# SL 2006-002

Used On: 323-001 FIRE ATTACK SYSTEM .....

# Installation of 323-001 Dual "L" Foam Bags

No: Service Letter 2006-002 - HeliAir

Figure 7-11, Foam System Installation (P/N 323-205 001-002B\_DCN53885459)

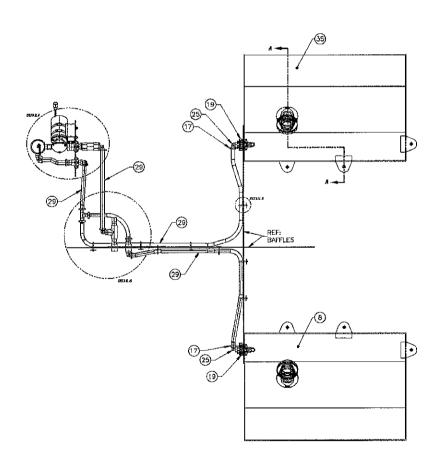
- 3. Reach up inside the tank through the fire attack doors on the bottom of the tank and manually break the 90 degree PVC plastic adapter fitting (item 25 on page 6) on the outlet of each bag. This will allow you to more easily remove the hose from the fitting.

- 4. Remove the PVC schedule 80 nut (item 19) from both forward and aft outlet fittings on the bags located at the bulkhead and fiberglass support bracket. Save these nuts for re-installation.

Fig 7-11, Foam Tank Installation (Continued)

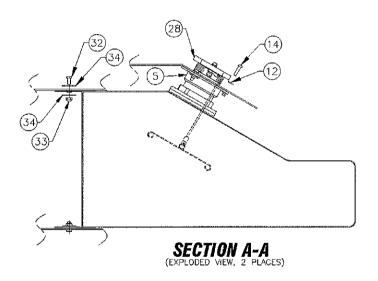
- 1. Flush and drain as much foam/retardant as is practical from the right and left hand bags.
- 2. Locate the three screws and washers (see items 12 and 14 on page 7) around each fill port of both the right and left foam bags. Remove them and save for re-installation. Push the filler cap firmly inward to break the RTV silicon bond between the filler and the tank.

- 5. Remove the bags from the tank through the bottom fire attack doors.
- 6. Remove (item 5 on page 7) from each of the old bags and install on the new bags.
